Public			
 NATIONAL CAPITAL COMMISSION COMMISSION DE LA CAPITALE NATIONALE		No.	2025-P222
		To	Board of Directors
For	DECISION	Date	2025-01-23
Subject/Title			
Federal Land Use and Design Approval for the Public Services and Procurement Canada (PSPC) and National Capital Commission (NCC) Alexandra Bridge Replacement Project – 15% Schematic Design			
Summary			
<ul style="list-style-type: none"> The purpose of this submission is to present the evaluation process and obtain land use and design approval from the Board of Directors for the recommended concept design for the replacement of the Alexandra Bridge. This approval will allow the Integrated Project Team to continue design work for the new bridge and produce a final schematic design. 			
Risk Summary			
As this submission formalizes the identification of a preferred schematic design concept for the bridge replacement, there are risks of public or stakeholder concerns in relation to the proposed bridge's schematic design. Compliance with the applicable Performance Criteria, management of project schedule and cost have also been identified as potential risks.

Recommendation			
<ul style="list-style-type: none"> THAT the Federal

Figure 1 - Three Retained Design Concepts – Echo (top), Rendez vous (centre), Motion (bottom)

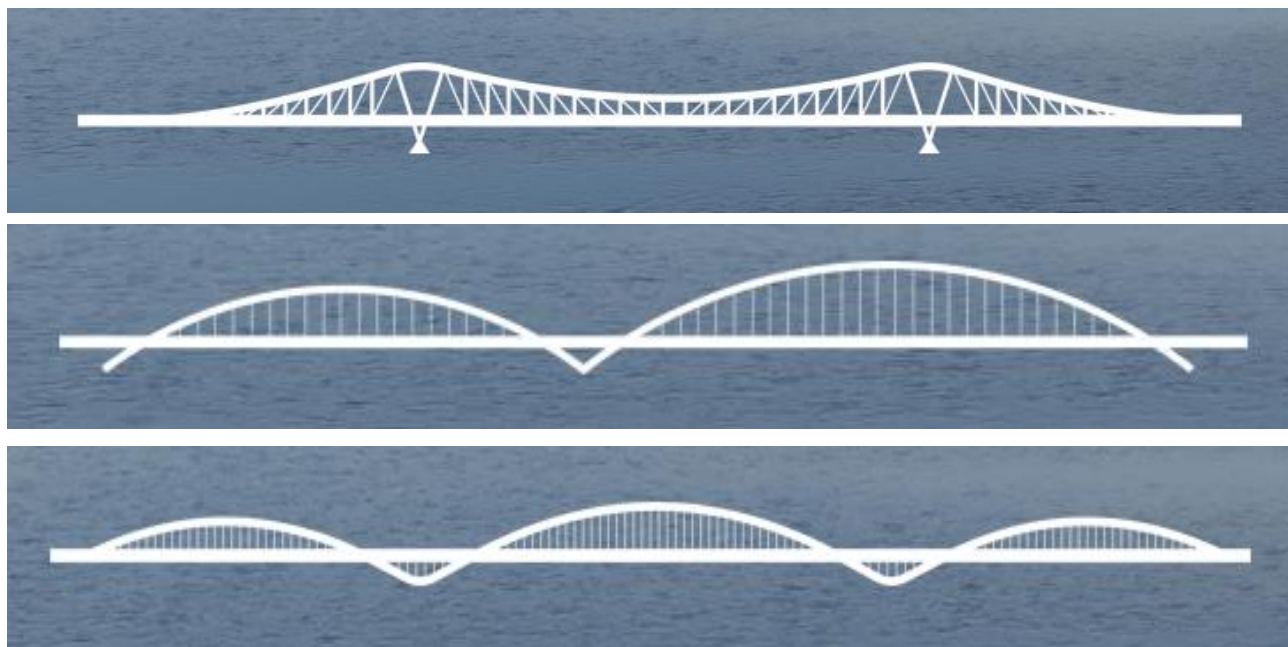
- The FLUDTA review confirmed that "Motion" is compliant with the *Performance Criteria for Bridge Design* across all applicable sections (Urban Design Framework, Public Space, Bridge Expression and Views and Visual Experience). The design response to other performance criteria will be advanced as the project team's design work continues.
- Of the three retained concepts from the long list of options, Motion was the most significantly evolved to improve integration with the surrounding cultural landscape and is supported by a well-developed design narrative reflective of input received from Indigenous communities and the design experts represented on the Independent Review Panel, ACPDR and ACUA.

- The overall scale of this revised concept is viewed to be cohesive with the surrounding topography (UD1a, UD1b, BE2c, BE2d). Motion’s arches have a symmetrical vertical profile featuring two arches that are 3.5 metres lower than the existing bridge and the one centre arch that is 3.5 metres taller.

- As noted through the Integrated Project Team's evaluation of the concepts, further consideration will be required to address possible impacts to river navigation around the wharf on the Gatineau shoreline. It is expected that the overall design of the selected concept will continue to evolve as design development continues and further input is received. Future iterations of the design will incorporate improvements and additional detail.
